FORESTSIDE TOWNHOUSES

TENDER ADDENDUM # 2

JAP Project No: 19066

The following revisions have been made to the drawing set:

Job No.: 19066 Sheet No.: S-101A

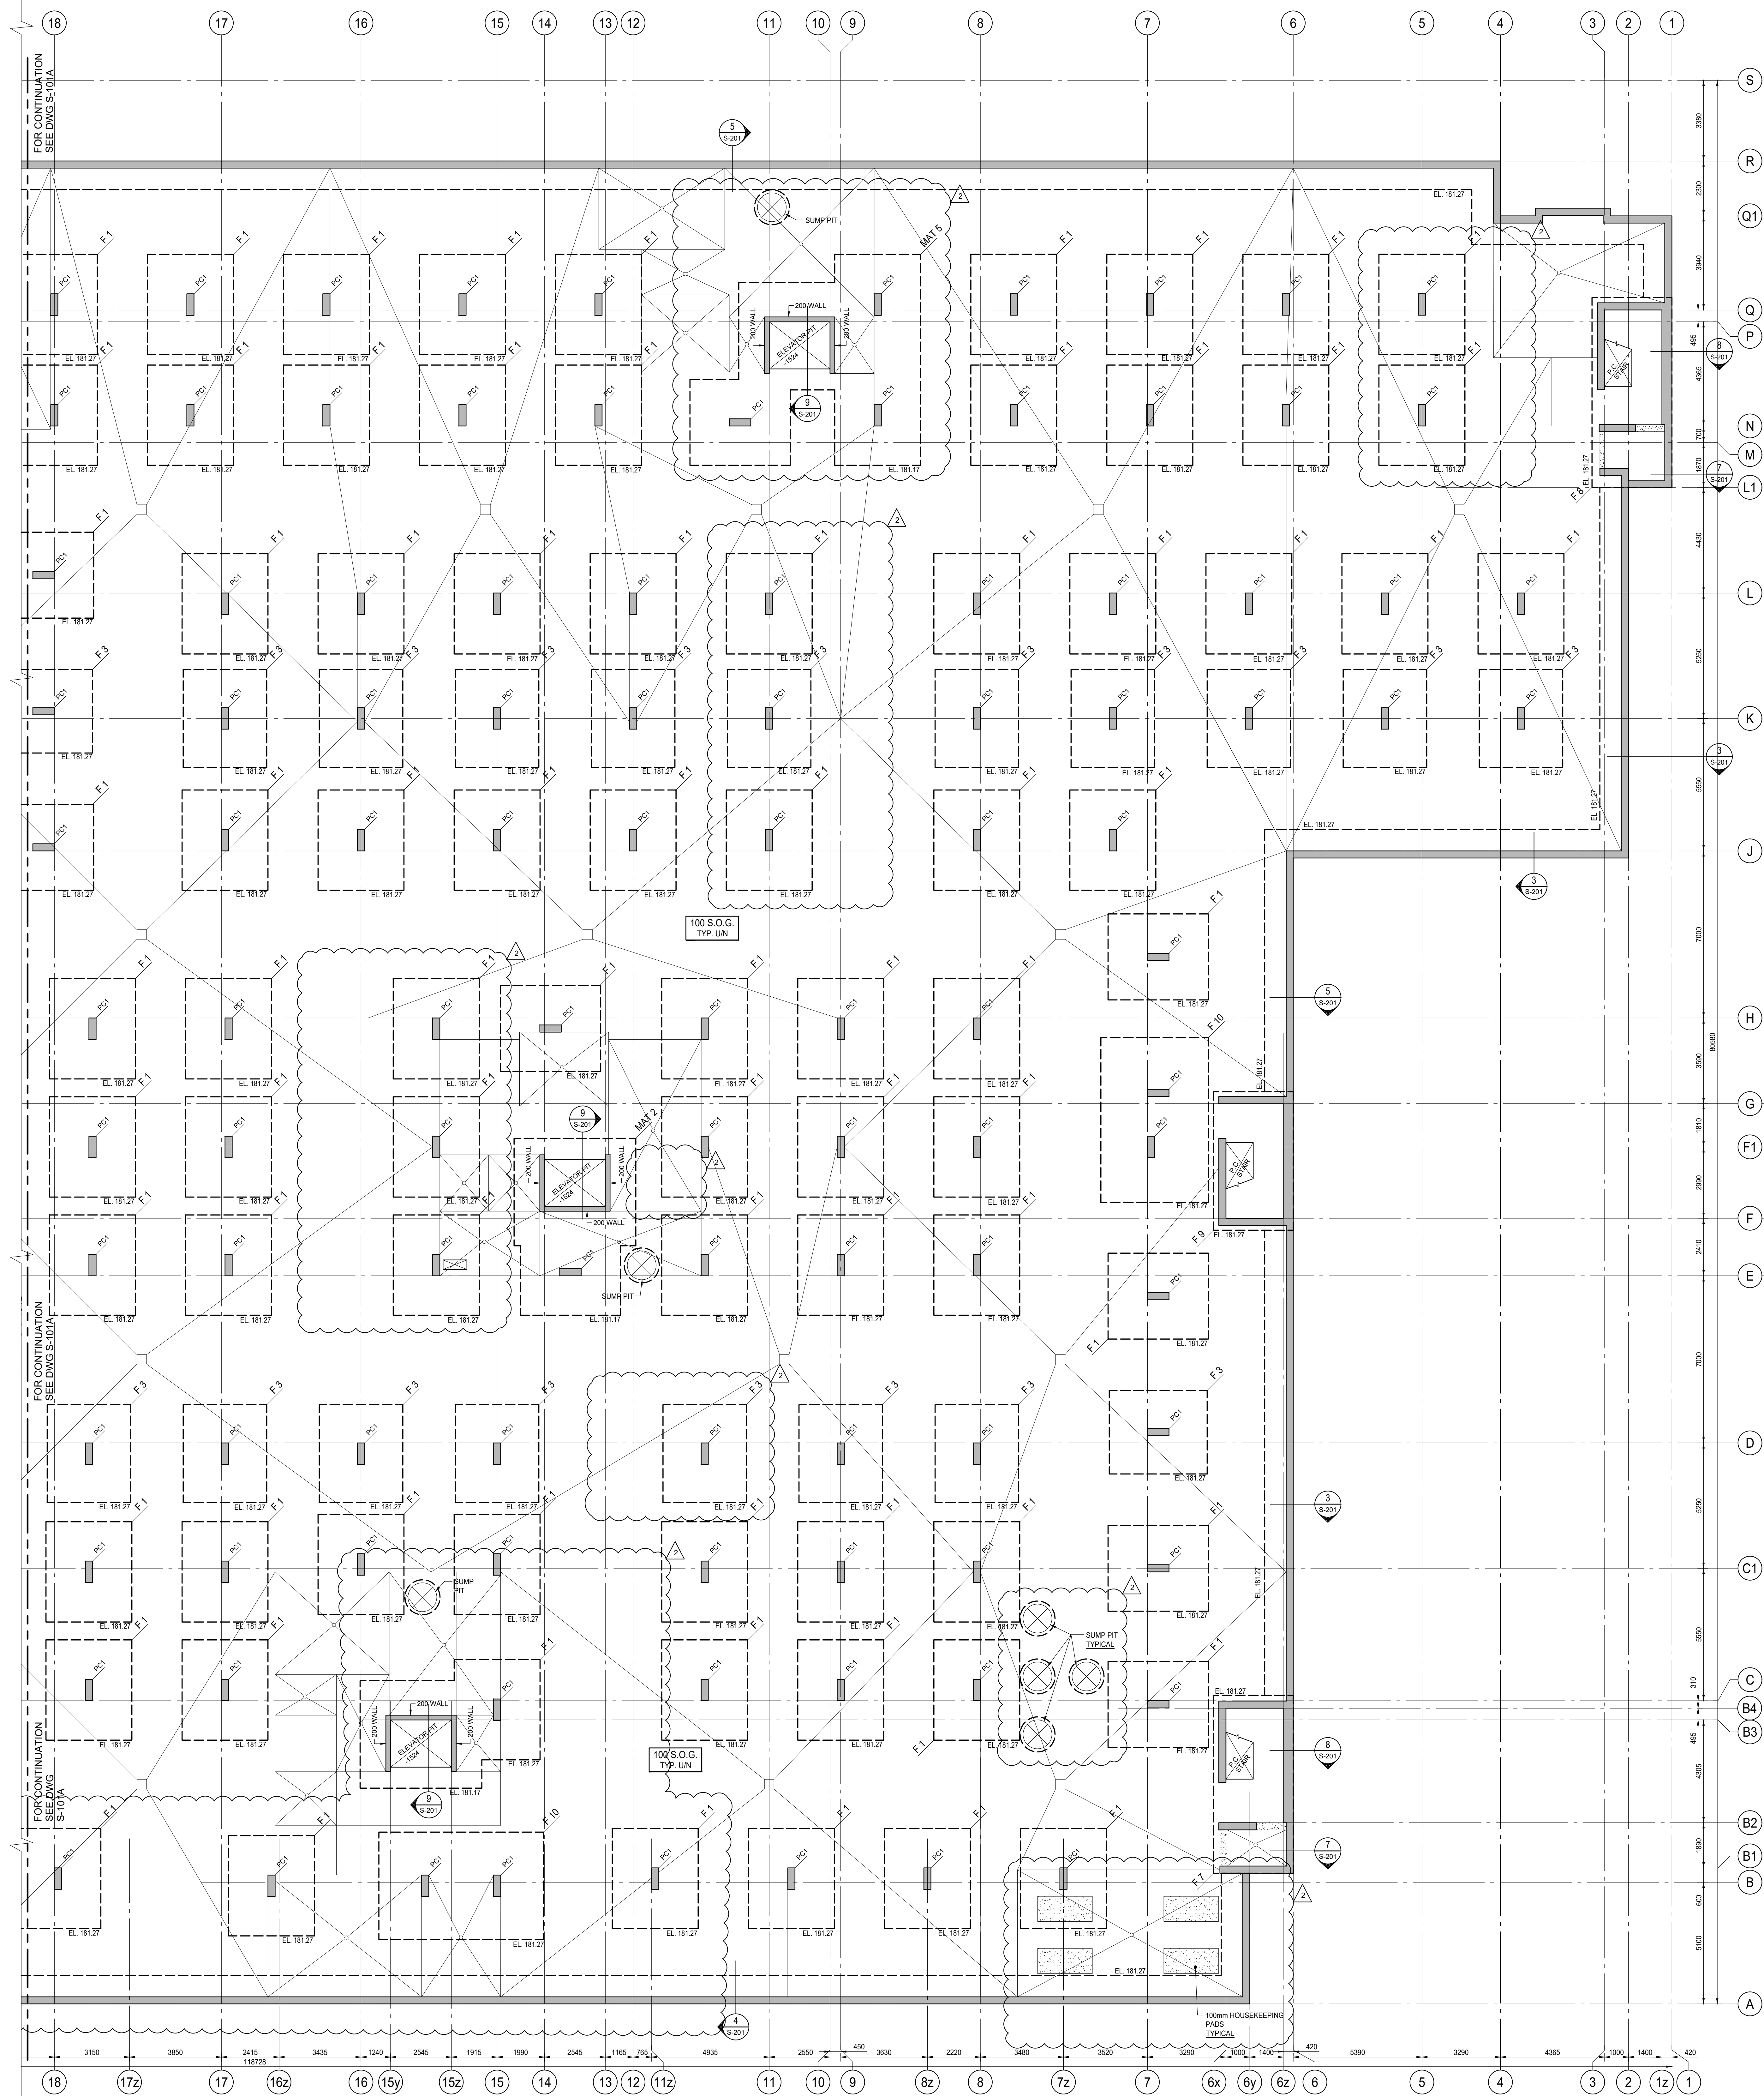
- 1.1 **Refer to Drawing S-101A & B "P1 Level Framing Plan"**
 - a) Updated column locations to match architectural
 - b) Updated footings accordingly
 - c) Added sump pit locations
 - d) Added note for reinforcement and dowels of non load bearing block walls
 - e) Deleted storm water tank
- 1.2 **Refer to Drawing S-102A & B "Ground Floor Framing Plan"**
 - f) Updated column locations below to match architectural
- 1.3 **Refer to Drawing S-201 "Foundation Sections"**
 - a) Label lean mix in all sections
 - b) Delete 10/S-201
- 1.4 **Refer to Drawing S-251 "Floor Sections"**
 - c) Updated 1/S-251
- 1.5 **Refer to Drawing S-301 "Footing Schedule"**
 - d) Added information for Mat 6
